Re: Chevron Mining, Inc. (CMI), Questa Mine; Major Individual Permit; SIC 1061; NPDES Compliance Evaluation Inspection (CEI); NM0022306; September 28, 2015

NPDES Compliance Inspection Report

Chevron Mining Inc. (CMI)
Questa Mine
Compliance Evaluation Inspection
NPDES Permit No. NM0022306
September 28, 2015

**Re: Chevron Mining Inc. – Questa Mine – NPDES NM0022306
Response to Compliance Evaluation Inspection Report
Dated October 29, 2015**

FIGURE E-1
PREFERRED TREATMENT PROCESS
(ECP + HIGH RECOVERY NF)

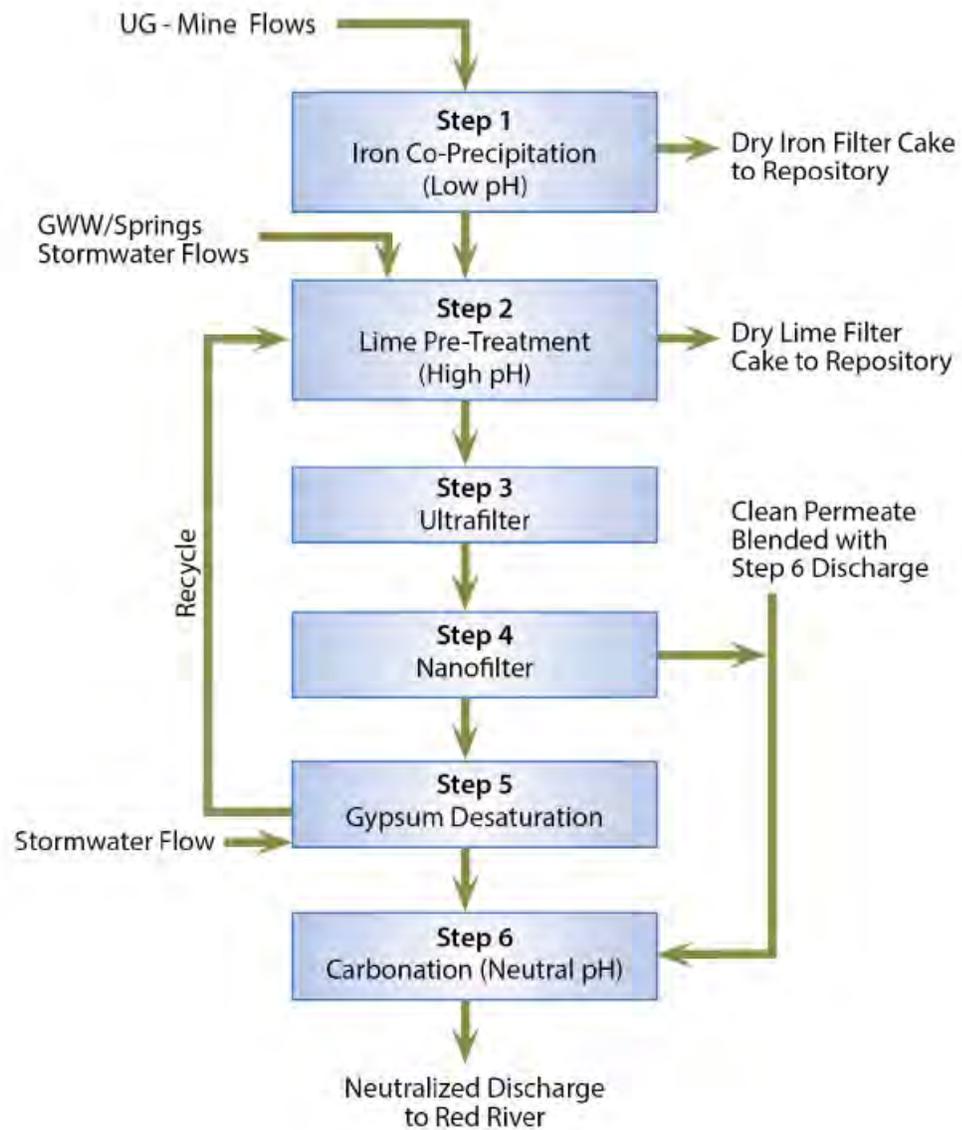
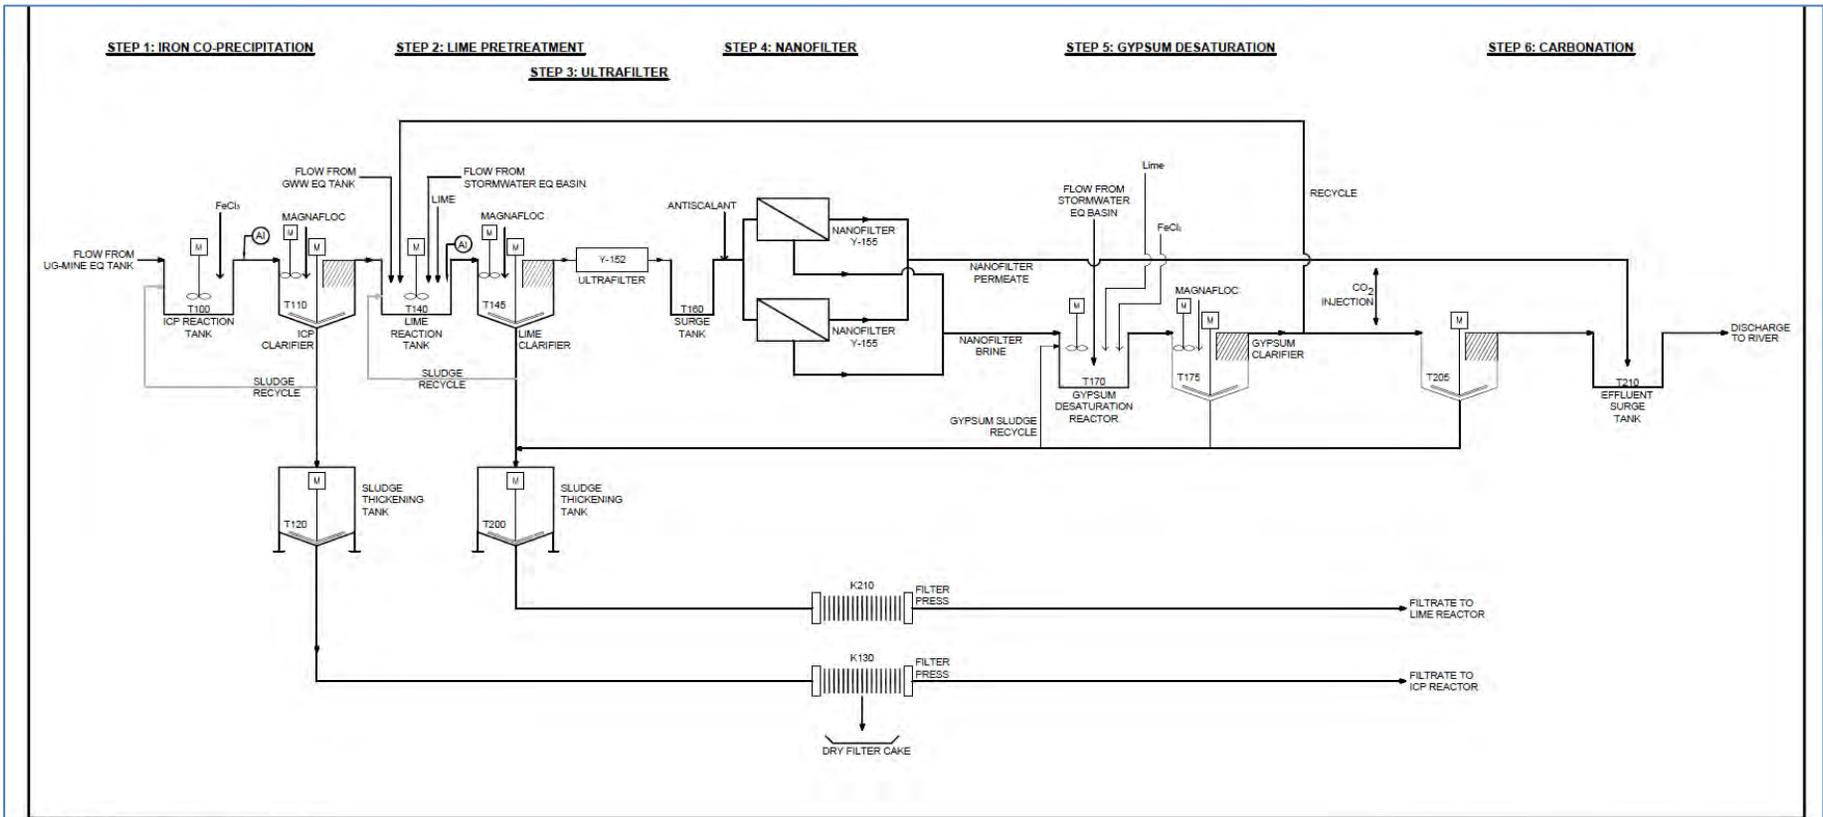
CMI’s Final Treatability Study Evaluation Report Questa Mine Water Treatment Pilot Study was completed in February of 2015. Selected figures from the 2015 Final Treatability Study Evaluation Report are attached. As described in the Final Treatability Study Evaluation Report, the treatment process collected mine dewatering, groundwater withdrawal well system, seepage interception systems at Spring 13 and 39, seepage interception systems at the base of Capulin and Goathill North waste rock piles, and groundwater extraction well systems is to include Enhanced Chemical Precipitation + Nanofiltration (ECP + NF) for the contaminants of concern (COCs). Section 9.1 of the 2015 Final Treatability Study Evaluation Report states *“The treatment process comprised of ECP + High Recovery NF (see Figure 9-1) is the preferred technology based on the results of pilot testing. The pilot study results demonstrate that this process is capable of meeting water treatment test levels for all COCs, with exceptions noted above for fluoride. Pilot testing shows that activated alumina is a viable treatment process for removing fluoride to below 1 mg/L. Activated aluminum can be added to the ECP + High Recovery NF treatment train at a later date if fluoride limits are required in a future NPDES discharge permit.”*
